Abstract

The design of a daisy chain battery system, while fairly straightforward, has a number of design elements that can become obstacles to implementation. This case study provides a glimpse into the questions and responses in the development of one daisy chain system.

The ISL78600 and ISL78610 are Li-ion battery manager ICs that supervise up to 12 series connected cells. The parts perform accurate monitoring, cell balancing and extensive system diagnostics functions. The devices communicate to a host microcontroller via an SPI interface and to other ISL78600, ISL78610 devices using a robust, proprietary, 2-wire daisy chain system.

FIGURE 1. INITIAL VBAT CONNECTION

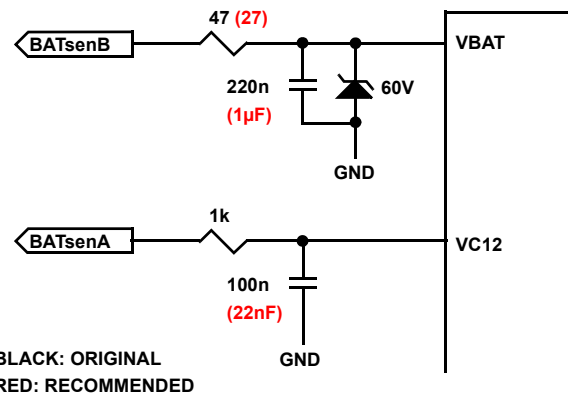
The VBAT input resistor was not damaged. Attached is a schematic of the VBAT connection.

Normally, we recommend a 27Ω resistor. While a 47Ω resistor may be OK, what happens is that the voltage at the VBAT pin drops when there is higher current, like during SPI or daisy chain communications. If the voltage drops too much, then there is not enough headroom on the front end analog circuits and there can be measurement errors. So, if the input resistor is not damaged then try a 27Ω resistor to see if this makes a difference.

The schematic shows two connections to the top of the stack, one for VBAT and one for VC12. This is OK, however, check to see if there is a fault condition. If the BATsenB wire is broken, it could affect the measurement accuracy, however, this would also show up as an open VBAT fault.

Another recommendation we make on the input filters is that the time constants on all inputs be the same (or about the same). In this case, the cell input time constant is about 16 times the VBAT time constant. If there are high voltage transients on the pack voltage, the differential time constants will result in high voltage differentials on the IC input pins. To minimize this, we recommend different filter values, as shown in RED in [Figure 1 on page 2](#).

FIGURE 6. CUSTOMER ORIGINAL DAISY CHAIN CONTROL CONNECTIONS

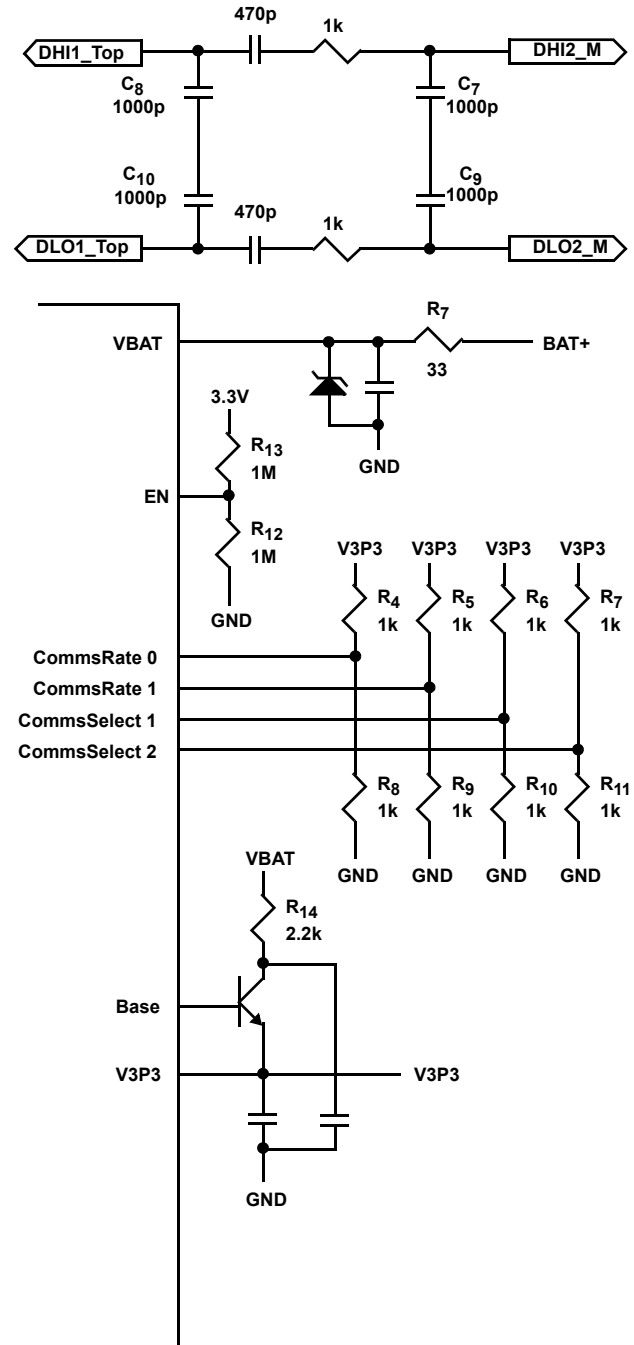
Resistor R_{12} is not loaded and the Comms pull-up/pull-down resistors are loaded according to the configuration settings above. I measured the voltage across the resistor, R_7 , in the schematic. The master bottom device is currently reading 11.9mV (360 μ A) and the top device is currently reading 2.4mV (72 μ A). Neither of these currents are popping off the datasheet to tell me what is going on.

The first thing to notice on the schematic is that the center point of the capacitors C₈ and C₁₀ (and C₇ and C₉) should be at the respective IC GND (see [Figure 7](#)).

1. Resistor R₁₄ is probably too big. This will work OK for stand-alone, however, because of higher currents in the Daisy Chain mode, it might cause the 3.3V supply to drop out during communications. In our designs, we use a 100 Ω resistor.
2. On the V3P3 regulator, the collector resistor R₁₄ is shown to connect to VBAT. This should connect to BAT+, otherwise the V3P3 current will also flow through R₇, reducing the VBAT voltage.

The observation that current across R₇ is only 360 μA indicates that the device thinks it is a stand-alone device (i.e., Comms Select pins both at 0). Please check this.

FIGURE 8. CUSTOMER REPORTED CORRECT STAND-ALONE COMMUNICATION

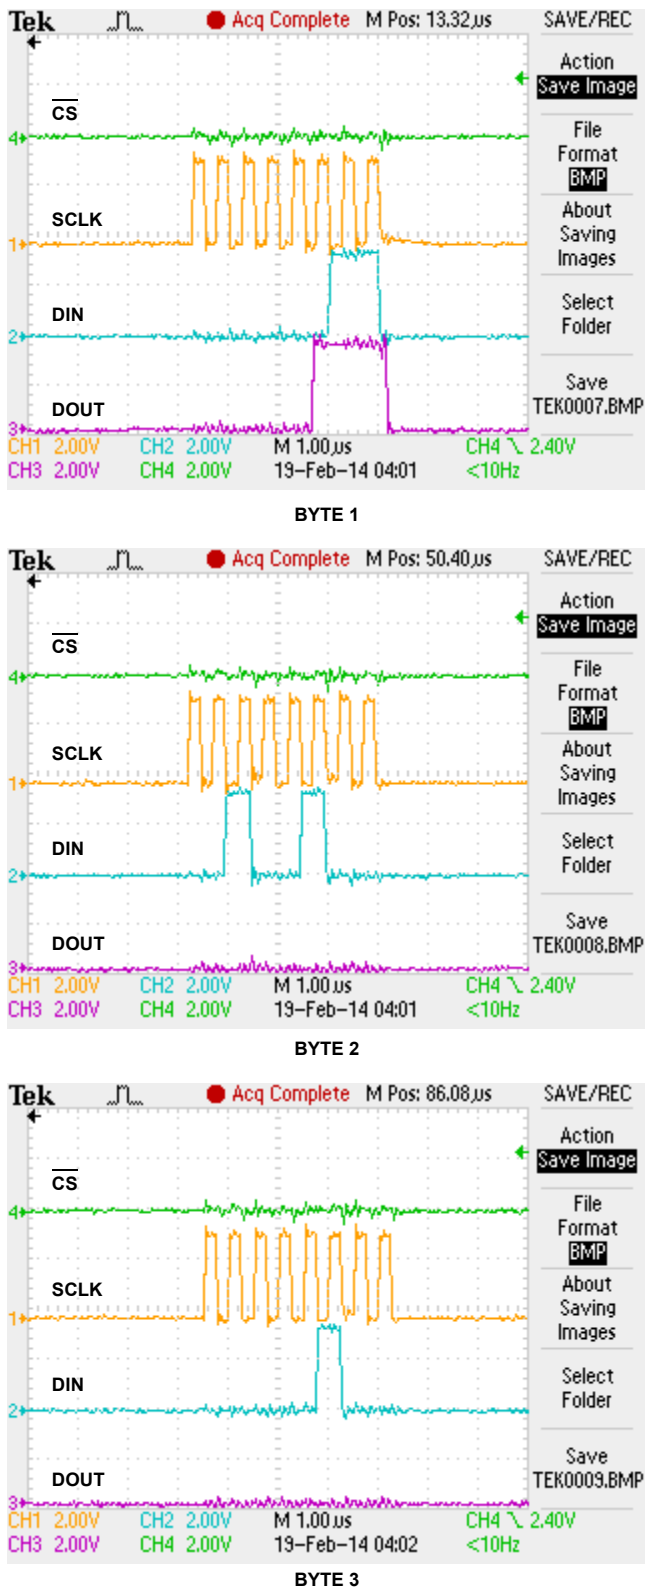
[Figure 8 on page 9](#) shows the SPI Identify command. The MISO data looks like 0x070000 but that's nothing valid to the best of my knowledge. If I send this command a few times in a row, I can get the MISO data to be 0x133800, which looks like a Comms Failure to me.

A: The fact that the upper device does not recognize the sleep/wake commands and there is no movement on the daisy chain lines means that there is something wrong with the daisy chain. *Nothing else matters until this can be cleared up.*

FIGURE 10. CUSTOMER DHI/DLO TRACES

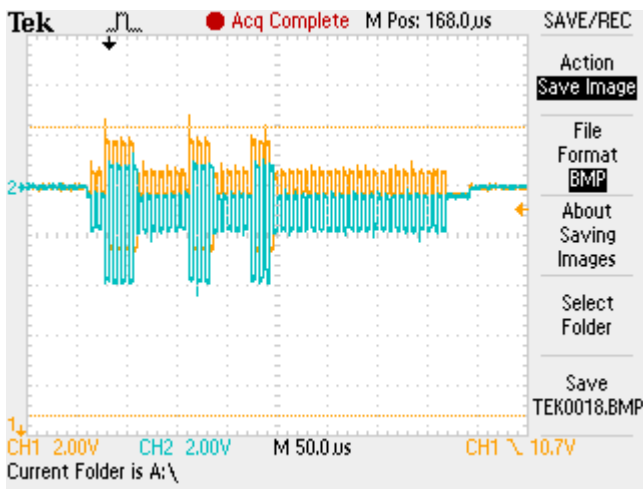
So, that looks good. [Figure 10](#) is the scope waveform for the master/bottom device's DHI2 and DLO2 lines, which actually look correct now while the daisy chain interface isn't connected. DLO2 is blue and DHI2 is orange.

The issue is that when I connected to the boards via the two daisy chain wires, the voltages on the master/bottom devices DHI2 and DLO2 go up to about ~22-23V.

A: The waveform in [Figure 10](#) looks almost correct for daisy chain communications, however, it is still not what you want to see. When the boards properly connect, you should see that the waveforms are more symmetrical vertically; and before and after the signals there should be an offset between the two traces (while here they appear to be the same voltage).

Since the voltages appear good before connecting the daisy chain wires, it looks like there is an isolation problem. Perhaps DHI2 and DLO2 on the top device are being connected to the DHI2 and DLO2 of the bottom device when you connect the two boards with the daisy chain wires. If so, then this would absolutely be a bad thing.

Check to make sure the top and bottom boards are completely isolated. Nothing on the top board should touch the bottom board, except the VSS of the top tying to the BAT+ of the bottom and the communications through the capacitors. The DHI2/DLO2 on the top board should be floating.

FIGURE 11. RECOMMENDED DAISY CONNECTIONS BETWEEN SEPARATE PCBs (COMPONENTS SELECTED FOR 500kHz DATA RATE)

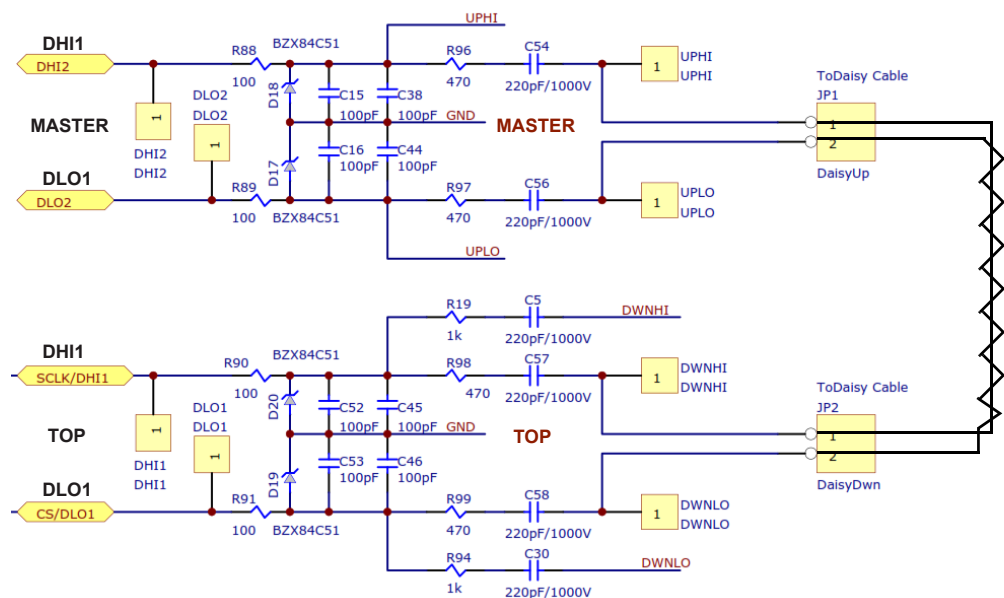
One other recommendation, if you have two boards connected by a cable, we normally recommend a daisy chain connection as shown in [Figure 11](#). This has components for faster daisy chain, however, what you might notice is that the up and down circuits are the same. This arrangement splits all of the components for symmetry, so if there is a break in the cable, the pins are isolated on both sides of the break. Even with a direct connection, this arrangement means that you do not need to bring the ground on the high side capacitors through the connector.

FIGURE 12. CUSTOMER DAISY WAVEFORMS AFTER CHANGES (GOOD)

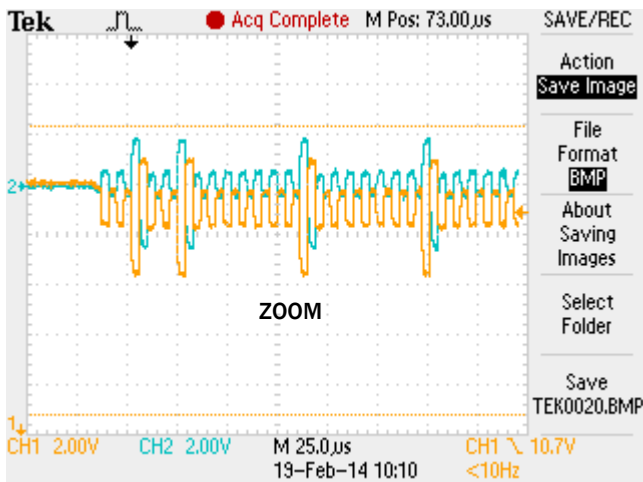
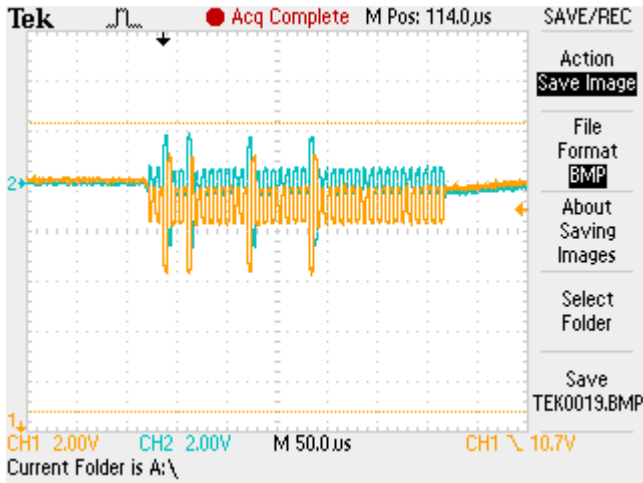
Q: Wow, it's been a long day. I think I finally got it right, however, I won't be able to check if valid data is coming back down the stack until tomorrow. [Figure 12](#) are two waveforms showing my daisy chain communication. What I sent you last time was just the master/bottom side, since connecting them had the isolation issue I described. Once I fixed the isolation issue, I connected the 2-wire daisy chain interface and captured the attached waveforms.

A: This looks better.

FIGURE 13. CUSTOMER BASE ID COMMAND (SPI)

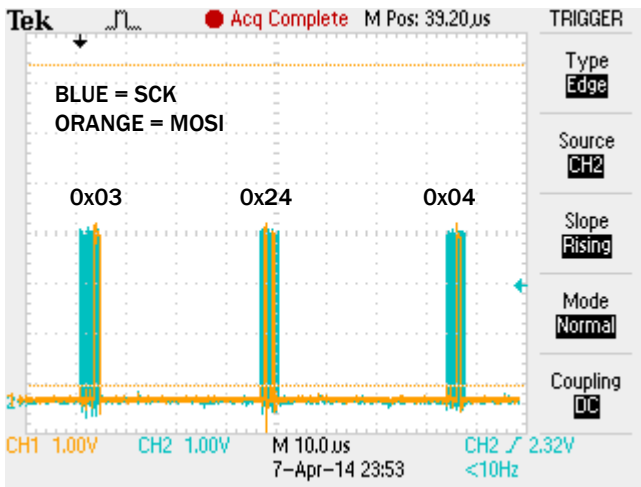
The 'base id command' waveform (Figure 13) shows the transmission of 0x03 24 04 from the Host MCU to the bottom/master device, specifically, the timing between SPI bytes in the overall transmission of this command. The timing shows that this command meets the 100µs maximum requirement defined as the \overline{CS} high time (the time between bytes). Please let me know if you see any concerns with the timing of my command transmission.

A: In response to your last question first, bringing \overline{CS} high between bytes is the proper way to send data.

FIGURE 14. CUSTOMER DATA READY RESPONSE HANDLING TIMING

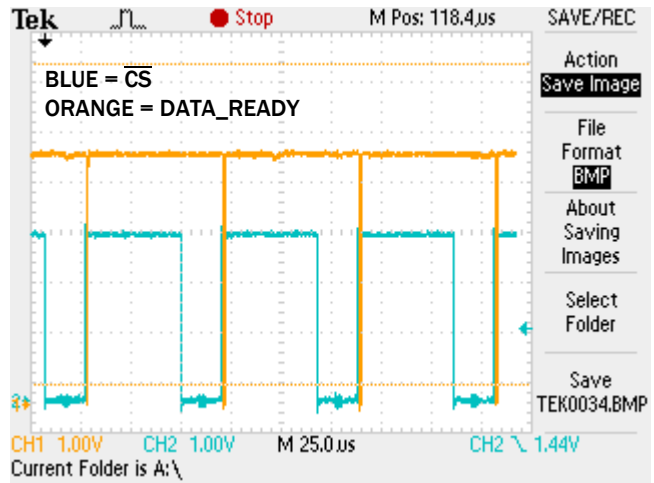
Also, the 'data_ready response handling' waveform (Figure 14), shows the timing on servicing the $\overline{DATA_READY}$ line. Please note that I have a level shifter that inverts $\overline{DATA_READY}$ from the ISL78600. As shown in the waveform, the $\overline{DATA_READY}$ signal goes HIGH when a byte is available in the ISL78600 buffer. The time that \overline{CS} is low is the time it takes for me to read a SPI byte (~25µs). At the completion of each read with the rising edge of \overline{CS} , you can see $\overline{DATA_READY}$ dip low briefly and return HIGH, indicating another byte is available. The time from the rising edge of $\overline{DATA_READY}$ to \overline{CS} going low again is the time it takes for me to respond to the $\overline{DATA_READY}$ signal (~45-50µs). Do you think this is too long?

I went through some timing diagrams from tests I did a while ago and found a scope shot of an identify sequence from our board. See [Figure 16](#). You can see that our response to data ready (the "0" trace) is much faster than yours and is about 3-4 μ s delay from falling edge of data ready to the start of SPI communication.
